PCN

RF360 SAW components in ceramic SMD packages for automotive electronics

Product / Process Change Notification

1. ID No.: M306		2. Date of announcement: December 8, 2017
3. Product / product group: 1) SAW AE SMD components 2) SAW AE SMD components with PSN passivation, LT-Zer0-TCF and HQTCF		
Old ordering code: 1) SAW AE SMD components: B39*R* B39*B33* B39*B34* B39*B35* B39*B37* B39*B39* B39232B1644U510 B39232B1646U410 B39152B1647U510 B39152B1664U410 B39152B1669U410 B39*B17* B39800X3403H810 B39162B4050U510 B39162B4060U810 B39192B4143U410 B39841B4147U410 B39881B4146U510 2) SAW AE SMD components with PSN passivation, LT-Zer0 TCF and HQTCF: B39162B3400U410 B39162B3401B710 B39232B3404U410 B39162B3405H910 B39162B3413U410 B39152B3421U410 B39162B3423U410 B39162B3424U410 B39232B3425U510 B39511B3426U410 B39481B3427U410 B39132B3428U410 B39911B3429U410	New ordering code: no change	Customer part number:

Fig: Comparison of markings on ceramic SMD components

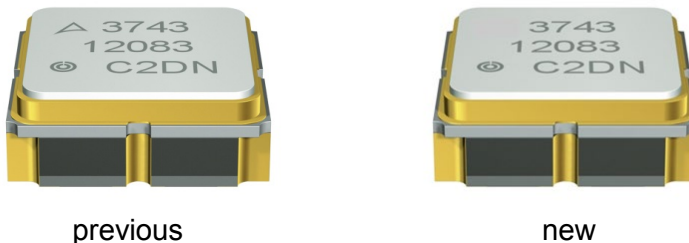
The EPCOS logo will be removed from the upper left corner of the marking of RF360 SAW components in ceramic SMD packages for automotive electronics. All other marking elements (i.e. part number, lot number and date code) will remain unchanged.
